Item Name: Crosstube Turning Detail

DRAWING NO. D212-664-141	TITLE XTUBE ASSY (205/212/412 HI FWD)	REV. D	DART AEROSPACE LTD ENGINEERING ORDER		D.E.O. NO. D212-664-141-D-1	SHEET NO. SHEET 1 OF 2	SCALE NTS
DRAWN	CHECKED	MFG. APPR.	APPROVED	DE APPR.			
DATE 11.04.07	DATE 11.04.11	DATE 11.04.12	DATE 11/04/12	DATE 11.04.12

PURPOSE:

ADD AN INSPECTION WINDOW TO UNDERSIDE OF CROSSTUBE.

**D212-664-141/-141B
ASSEMBLY DETAIL**

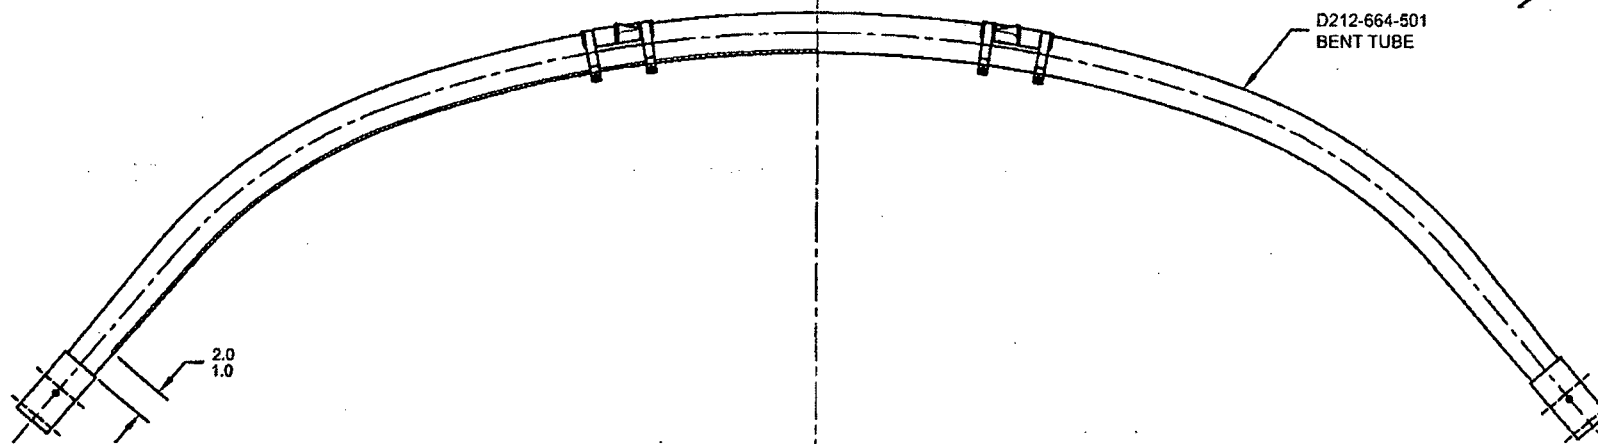
NOTES 2 OF SHEET 1 IS AMENDED AS FOLLOWS:

- 2) FINISH: CHEMICAL CONVERSION COAT PER DART QSI 005 4.1
PRIME INSIDE AND OUTSIDE PER DART QSI 005 4.2
MASK UNDERSIDE OF CROSSTUBE AS SHOWN (HATCHED AREA) AND
PAINT OUTSIDE PER DART QSI 005 4.2
REMOVE MASKING AND APPLY CLEAR COAT

- 2) FINISH: CHEMICAL CONVERSION COAT PER DART QSI 005 4.1
PRIME INSIDE AND OUTSIDE PER DART QSI 005 4.2
PAINT OUTSIDE PER DART QSI 005 4.2

MASK AREA PRIOR TO PAINTING,
REMOVE MASKING AFTER PAINT
AND APPLY CLEAR COAT
